# Access Compliance Report

## Public Rights-of-Way

### (Curb Ramps)

Intersection ID: 10034710	Main Street: POINDEXTER_DR	Cross Street: N/A	Location:	N
ADA ID: A74599871BEE	Ramp Type: Perp	Initial Pass/Fail: Fail	Overall Compliance: No	Severity Score: 12.5
Codes/Mitigation Info/Possible Solution		Field Measurements/Component Compliance

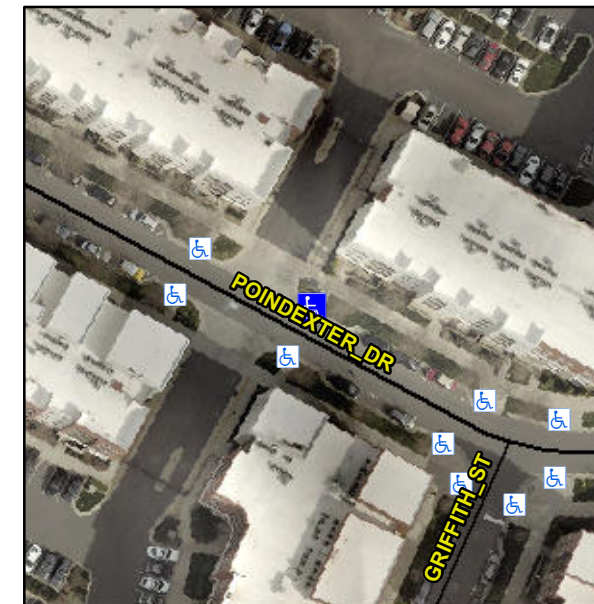
**Remove & Replace Entire Ramp.**

**R304.2.2**

Compliance	Description	Data	Compliance	Description	Data
N/A	Ramp Length (in)	72.0	No	Ramp Slope (%)	9.1
Yes	Ramp Width (in)	59.0	Yes	Ramp XSlope (%)	0.7
N/A	Flare Type LT	N/A	N/A	Flare Type RT	N/A
N/A	Flare Slope LT (%)	N/A	N/A	Flare Slope RT (%)	N/A
N/A	Flare Traversable LT?	N/A	N/A	Flare Traversable RT?	N/A
N/A	Landing Length (in)	N/A	N/A	DWS Provided?	N/A
N/A	Landing Width (in)	N/A	N/A	DWS Contrast?	N/A
N/A	Landing Slope (%)	N/A	N/A	DWS Length (in)	N/A
N/A	Landing X Slope (%)	N/A	N/A	DWS Full Width?	N/A
N/A	Landing Curb? (Y/N)	N/A	N/A	DWS Offset (in)	N/A
N/A	Shared Landing?	N/A			
N/A	Gutter Ponding?	N/A	N/A	Gutter Slope (%)	N/A
N/A	Gutter Lip Ht (in)	N/A	N/A	Gutter X Slope (%)	N/A
N/A	Painted X Walk1?	No	N/A	Painted X Walk2?	N/A
	X Walk 1 Direction	To SW		X Walk 2 Direction	N/A
N/A	X Walk 1 Width (in)	N/A	N/A	X Walk 2 Width (in)	N/A
	X Walk 1 Slope (%)	0.6		X Walk 2 Slope (%)	N/A
	X Walk 1 X Slope (%)	0.5		X Walk 2 X Slope (%)	N/A
